VIRGINIA ELECTRIC AND POWER COMPANY
RICHMOND, VIRGINIA 23261

VIRGINIA ELECTRIC AND POWER COMPANY
NORTH ANNA POWER STATION UNITS 1 AND 2
PROPOSED TEMPORARY TECHNICAL SPECIFICATIONS CHANGE
SERVICE WATER SYSTEM PIPING REPAIR/REFURBISHMENT

Discussion of Changes

FIGURE 2
SIMPLIFIED FLOW DIAGRAM - SW PIPING TO/FROM CCHXS
ALIGNMENT DURING REPAIRS OF HEADER A (LINES 24"-WS-95 & 24"-WS-102)

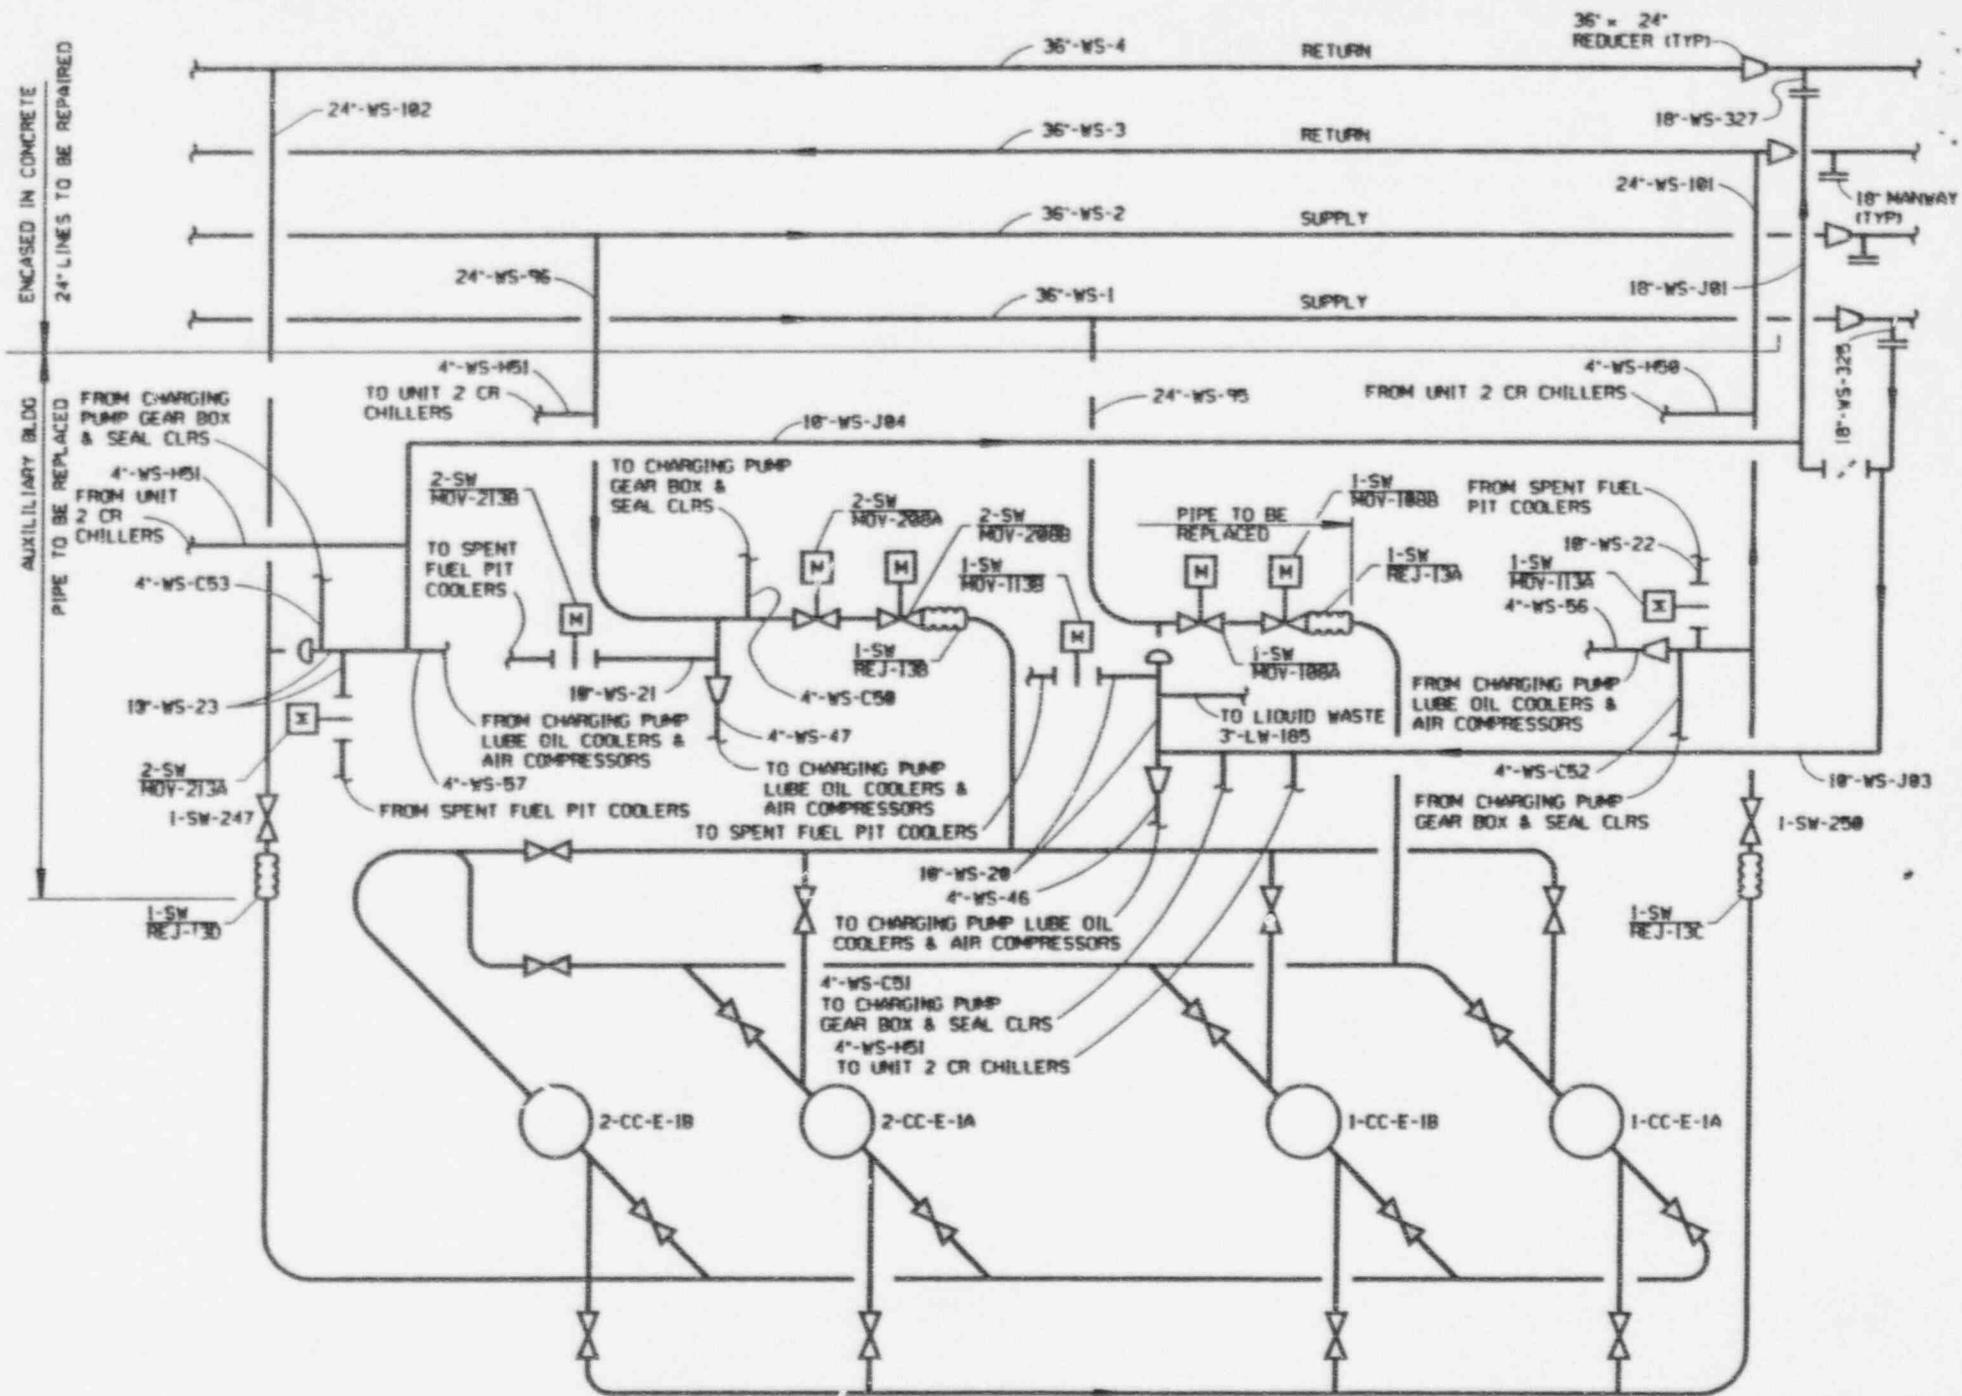
- First, it is necessary to isolate and blank the 24-inch SW header to/from the CCHXs and the above mentioned SW consumers. This is accomplished by isolating the entire "A" SW header using Action Statement "d" (the 168-hour Action Statement) of Technical Specification 3.7.4.1 and performing the following in sequence (refer to Figures 1 and 2):

- 3) Remove valves 1-SW-MOV-108A, 1-SW-MOV-108B, 1-SW-247 and expansion joints 1-SW-REJ-13A and 1-SW-REJ-13D. Install blind flanges in place of expansion joints 1-SW-REJ-13A and 1-SW-REJ-13D.

- 4) Install weld-in plugs in pipes 24"-WS-95-151-Q3 and 24"-WS-102-151-Q3 as close to 36" header as practical.

5) Install crossconnect 18"-WS-J01-151-Q3 and connect lines 10"-WS-J04-151-Q3 and 10"-WS-J03-151-Q3. Simultaneously connect the above 10" lines to valves 1-SW-MOV-113B and 2-SW-MOV-213A and 4" lines as shown on Figure 2.

During the proposed refurbishment activities, one of the two SW headers to/from the CCHXs would be blanked-off from the rest of the main SW loop. Temporary SW lines will be installed to supply the second source of SW to the charging pump coolers, SFP coolers, air compressor coolers and Unit 2 CR chillers (note, that SW lines to Unit 1 CR chillers are not affected by this repair work). These temporary lines will be routed from operating part of the 36" SW headers while the 24" headers to CCHXs are being repaired. Concurrently, a temporary cross-connect, with a manually operated butterfly valve, would be installed between the supply and return headers of the affected main SW loop to provide a flow path bypassing the CCHXs. The installation of a temporary bypass avoids
